**Figure 40** | Illustration of proposed setback Design Guidelines to Main Street (Source: Applicant's RRTS)

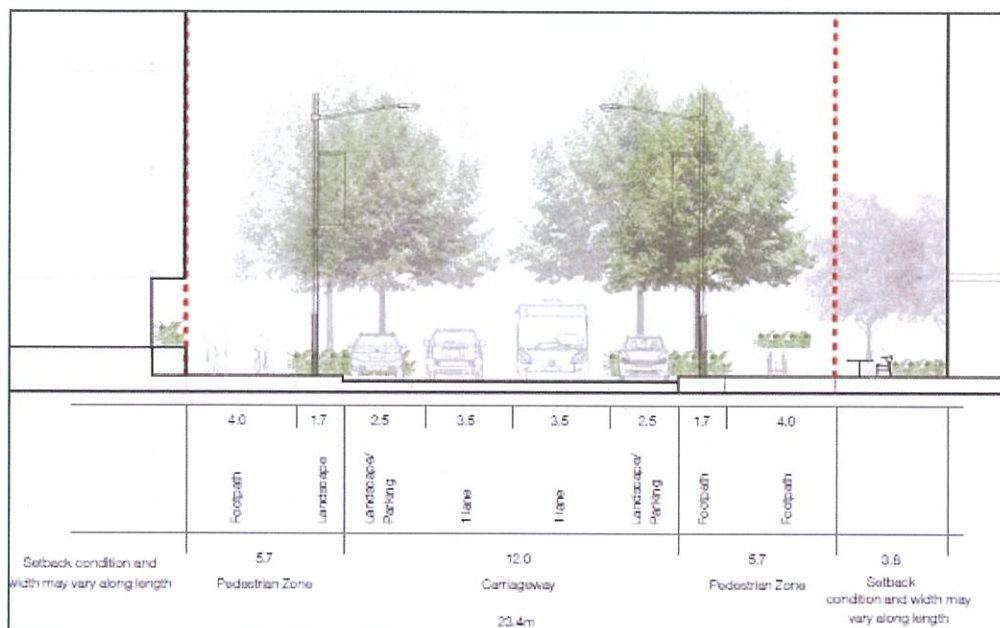
Council considers the proposed residential building setbacks to the public domain to be insufficient and a minimum 5 m landscaped setback should be provided between residential buildings and adjacent street footpaths to provide an improved public domain interface and privacy outcome for future ground floor residents. Alternatively, Council recommend a setback of 3 m provided ground floor apartments are raised up to 1 m above footpath level to provide increased privacy.

The Department considers the proposed building setbacks to the public domain would achieve a desirable visual outcome and are considered acceptable. As a future assessment requirement, future detailed applications would be required to consider residential privacy of ground floor apartments whilst ensuring an acceptable visual outcome. This would likely include the use of higher floor levels, landscaping and low scale screening.

**Figure 42** | Existing vegetation zones (Source: Applicant's EIS)

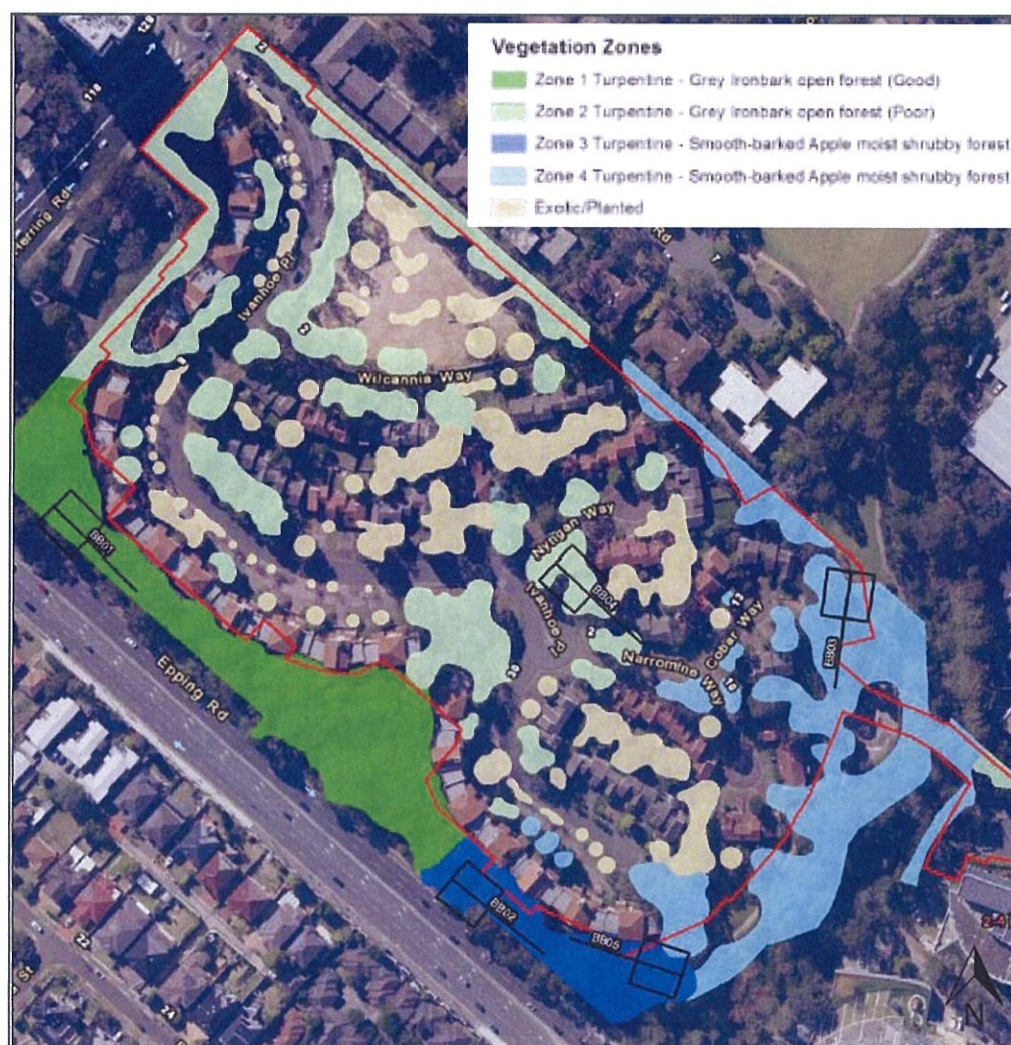
The site currently contains 3.4 hectares of vegetation, including over 1,000 trees. The trees comprise a mix of native and exotic species and includes dense concentrations along the Shrimptons Creek and Epping Road frontages. Two major plant communities exist on the site, which are the STIF and the Smooth-barked Apple-Turpentine-Blackbutt open forest, both located adjacent to Epping Road. **Figure 42** identifies the existing vegetation zones within the site. The 1.64 hectares of STIF (zone 1 in **Figure 42**) is a CEEC under the BC Act and EPBC Act.

**Figure 43** | Plan illustrating development footprint and tree impacts (Source: Applicant's RRTS)

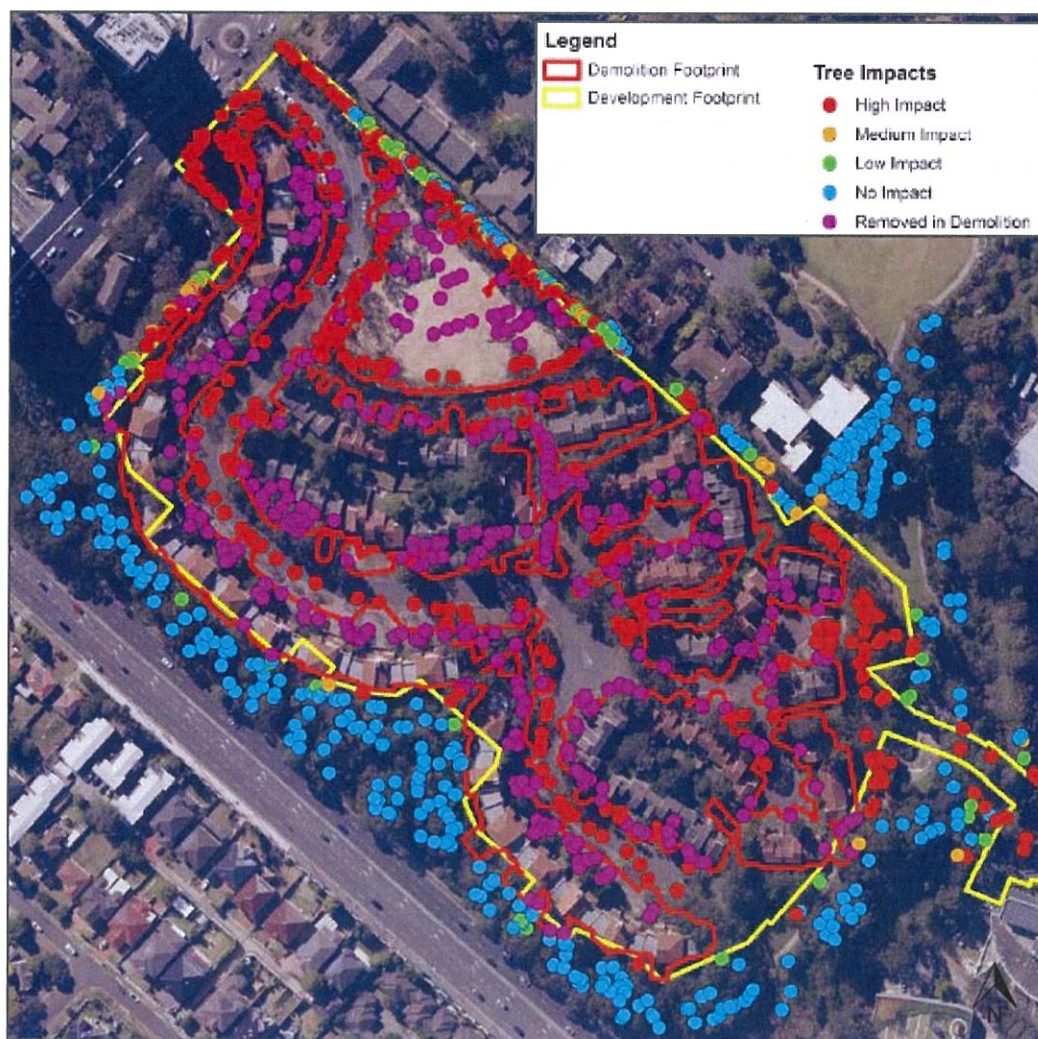
**Figure 43** illustrates the proposed development footprint and the location of trees subject to high impact/to be removed and the location of trees to be removed as part of the demolition.

The Department notes although the total number of trees to be removed on the site (including from demolition) has only decreased from 858 to 853, this was due to additional low-quality trees on the site being identified as removed throughout the assessment. Significantly, the overall number of trees being retained has increased by 222 from 231 to 453 and critically, the area of STIF to be impacted has been significantly reduced from the original exhibited concept plan (0.45 hectares) to the current concept plan (0.02 hectares) and, in total, 94% of the CEEC would be retained. The Department further notes the EESG have raised no objection to the revised proposal.

The Department considers the redevelopment of the site, consistent with the planning controls for the site, would unavoidably result in the loss of 853 trees. However, the Department considers the revised concept proposal has suitably sought to minimise tree loss and biodiversity impacts and is satisfied the potential impact to the STIF/CEEC has been minimised and trees around the Epping Road, Shrimptons Creek and Herring Road boundaries have been retained, where viable. Where impacts on the STIF are unavoidable, biodiversity offsets in accordance with the NSW Biodiversity Offsets Policy for Major Projects will be acquired and retired (**Section 7.7.2**).

Combined with the proposed planting of 950 replacement trees across the site, the Department considers the longer-term impact of the proposed tree removal would be suitably mitigated. Recommended conditions include a minimum of 950 trees are replanted on the site, including 476 trees as part of Stage 1. In addition, conditions require various measures to be implemented to avoid and minimise impacts, including implementation of a Biodiversity Management Plan and a Construction Environment Management Plan.

**Figure 1** | Height of Building map extracted from RLEP 2014. Site shown outlined in red. X = 45 m; AA1 = 65 m; AA2 = 75 m (Source: Applicant's EIS)

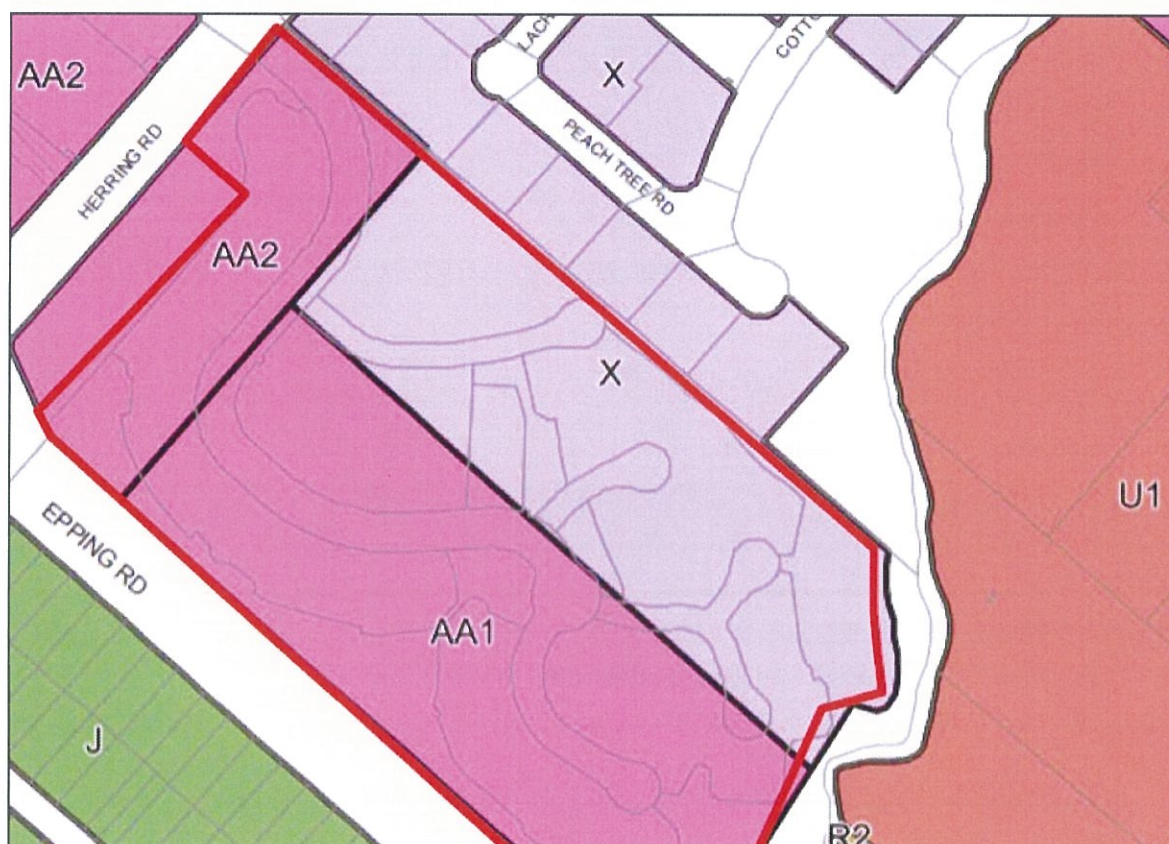
The concept proposal seeks a variation to the maximum building height as prescribed by clause 4.3 of the Ryde Local Environmental Plan 2014 (RLEP 2014). Clause 4.3 of the RLEP 2014 requires the height of a building on any land is not to exceed the maximum height shown for the land on the Height of Buildings Map. These are 75 m over the north-western portion adjacent to Herring Road and a small section of Epping Road, 65 m over the south-western portion adjacent to Epping Road and part of Shrimptons Creek, and 45 m over the remainder of the site (**Figure 1**).

Having considered the Applicant's written request and further to the Department's assessment of height in **Section 7.2.2**, the Department is satisfied the Applicant has adequately addressed there are sufficient environmental planning grounds to justify the contravention of the development standard and the matters required to be demonstrated have adequately been addressed. The Department therefore concludes that the Applicant's written request adequately addresses the matters required to be demonstrated under clause 4.6 of the RLEP 2014 and the proposed development will be in the public interest because it is consistent with the objectives of the building height standard and the objectives for development within the zone.
